In the Matter of
Sacramento Municipal Utility District
(Rancho Seco Nuclear Generating Station)
Docket No. 50-312 (SP)

REVIEW OF THE RANCHO SECO NUCLEAR GENERATING STATION
UNIT NO. 1 AUXILIARY FEEDWATER SYSTEM RELIABILITY ANALYSIS

D. Ilberg, R. Youngblood and I. A. Papazoglou

FIGURE - 1

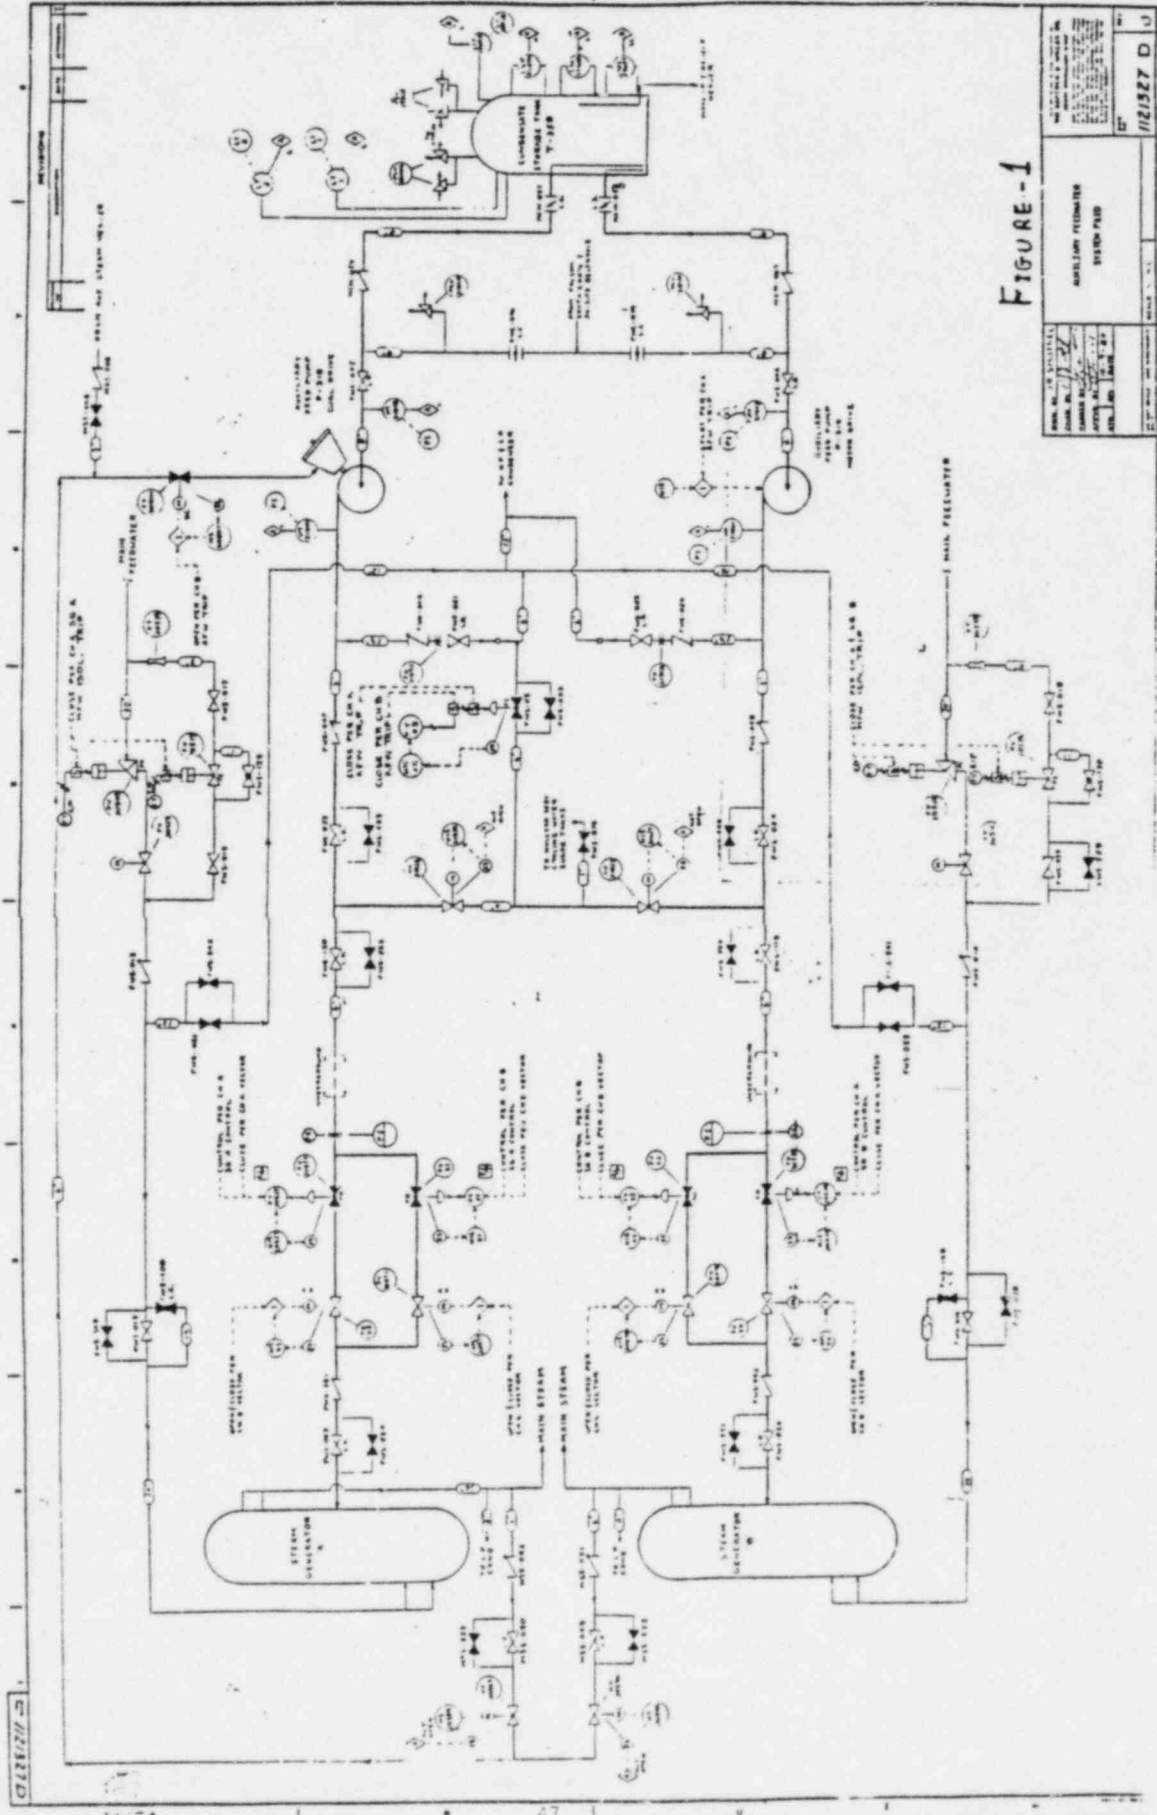
IS-1's AFW system (Figure -1) consists of two pump trains. Each pump has a separate suction line originating from the Condensate Storage Tank. The two discharge lines to the two steam-generators are interconnected, allowing each train to supply AFW to either or both steam-generators (SG). AFW Train A pump (AFW-1) is a combination turbine-driven motor-driven pump with both the turbine and electric motor on a common shaft. The turbine drive is used as the primary motive source for this pump. The motor drive can be manually initiated. AFW Train B pump (AFW-2) is a motor driven pump which has the same rated capacity and recirculation flow as AFW-1. Both AFW pumps are self contained entities without dependencies on secondary support systems for lubrication and for lube-oil cooling. The bearing on the turbine and both pumps are lubricated by slinging oil from reservoirs near the bearing. Lube oil cooling is accomplished by heat transfer to the pumped fluid.

The pumps discharge through check valves and locked open manual valves into cross-connected discharge lines. The cross-connection line contains two normally-open motor-operated valves. This cross-connect permits either pump to feed either or both of the SG's.

On each discharge line there are two flow control valves in parallel. They are all normally closed. Their control is pneumatic and is fail safe, i.e. fail open upon loss of air and half open upon loss of power (AC and DC). Downstream of the flow control valves are four motor-operated isolation valves (MOV's). They are installed in parallel, two on each discharge line. They are followed by check valves and locked-open manual valves.

The parallel arrangement of the flow control valves and MOV's on each discharge line may require isolation of the entire flow path to a steam generator each time any of these four valves in parallel requires maintenance action. In that case, both trains will be able to feed one SG only. However, in case of pump maintenance, the pump can be isolated by closing manual locked open valve in the suction line, and check valves isolate flow from the discharge and recirculation line side.

Pumps are assumed to be tested monthly. The test line recirculates water to the condenser via a normally closed air operated valve (FWS-X5). This valve fails safe upon loss of air to the closed position. It receives signals to close from both control channels A and B (EFIC -A and EFIC-B), whenever the AFW is initiated, to ensure its closed position and prevent flow diversion. The pump test verifies that the discharge line up to the cross-connect line and that the MOV's on this cross-connect are all open. It does not, however, check the conditions of the 8 valves in parallel on the discharge lines to both steam generators. The latter can be checked only during shutdown or emergency operation. Recirculation line for pump protection is provided through small lines to the condenser with normally locked open valves. It is not clear, however, whether there is always a redundant path arrangement or whether some lines are common to both pumps.

There are two interconnected trains in the AFWS (see Figure 1). Each train consists of one pump and one discharge line having two control and isolation valves in parallel. A cross-connect links the two discharge lines, and permits each pump to supply AFW to one or two discharge lines. A common test line having the same diameter as the discharge line permits full flow test of both pumps. Mission success is defined as adequate flow from one pump to one SG within the appropriate time.

Event Q_1Q_2 does not contain any significant single failures. Likewise event $A*B$ does not contain single failures. Event D includes the single test valve FWS-X5. A passive failure of this valve will open a flow path for both AFW trains which will bypass both steam generators. This path is 6" in diameter, the same diameter the discharge lines have. A passive failure with a failure rate of $10^{-7}/hr$ is assumed according to WASH-1400. It may yield a common mode failure probability of 10^{-4} , if special surveillance actions for this failure mode of the valve, are not taken during the period between regular maintenance schedules (assumed 4 1/2 month per NUREG-0611).

The four control valves depend on air, and are designed to fail open on loss of air. Valves in the same train are connected to different air sources. Thus, loss of one air train causes two valves to fail open. This does not prevent delivery of water to the steam generators, but leads in the direction of overcooling or overfilling.
